# Access Compliance Report

## Public Rights-of-Way

### (Curb Ramps)

Intersection ID: 47651	Main Street: MULLAN_LN	Cross Street: MORAY_CT	Location: NW
ADA ID: 2F19902AB259	Ramp Type: PerpDiag	Initial Pass/Fail: Fail	Overall Compliance: No
Severity Score: 10			
Codes/Mitigation Info/Possible Solution		Field Measurements/Component Compliance

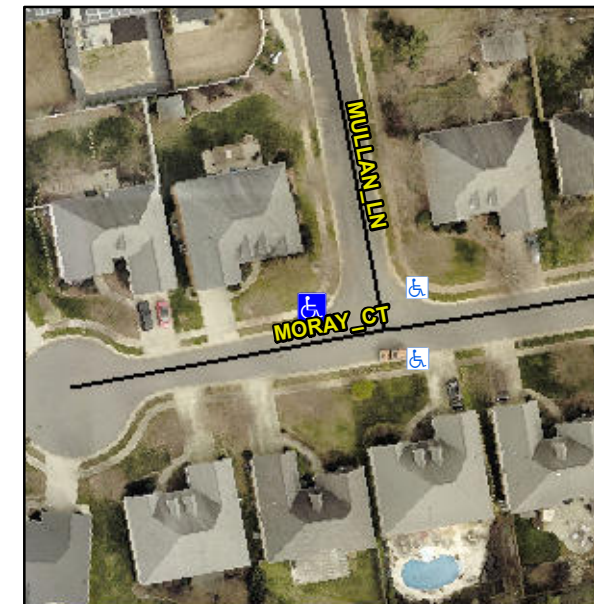
**Not Found, R304.5.1, R304.5.3**

Compliance	Description	Data	Compliance	Description	Data
N/A	Ramp Length (in)	58.0	Yes	Ramp Slope (%)	5.6
No	Ramp Width (in)	46.5	No	Ramp XSlope (%)	3.3
N/A	Flare Type LT	N/A	N/A	Flare Type RT	N/A
N/A	Flare Slope LT (%)	N/A	N/A	Flare Slope RT (%)	N/A
N/A	Flare Traversable LT?	N/A	N/A	Flare Traversable RT?	N/A
N/A	Landing Length (in)	N/A	N/A	DWS Provided?	N/A
N/A	Landing Width (in)	N/A	N/A	DWS Contrast?	N/A
N/A	Landing Slope (%)	N/A	N/A	DWS Length (in)	N/A
N/A	Landing X Slope (%)	N/A	N/A	DWS Full Width?	N/A
N/A	Landing Curb? (Y/N)	N/A	N/A	DWS Offset (in)	N/A
N/A	Shared Landing?	N/A			
N/A	Gutter Ponding?	N/A	N/A	Gutter Slope (%)	N/A
N/A	Gutter Lip Ht (in)	N/A	N/A	Gutter X Slope (%)	N/A
N/A	Painted X Walk1?	No	N/A	Painted X Walk2?	No
	X Walk 1 Direction	To S		X Walk 2 Direction	To E
N/A	X Walk 1 Width (in)	N/A	N/A	X Walk 2 Width (in)	N/A
	X Walk 1 Slope (%)	1.1		X Walk 2 Slope (%)	3.0
	X Walk 1 X Slope (%)	2.9		X Walk 2 X Slope (%)	0.4

**Remove & Replace Curb Ramp With Two New Directional Ramps or Equivalent.**
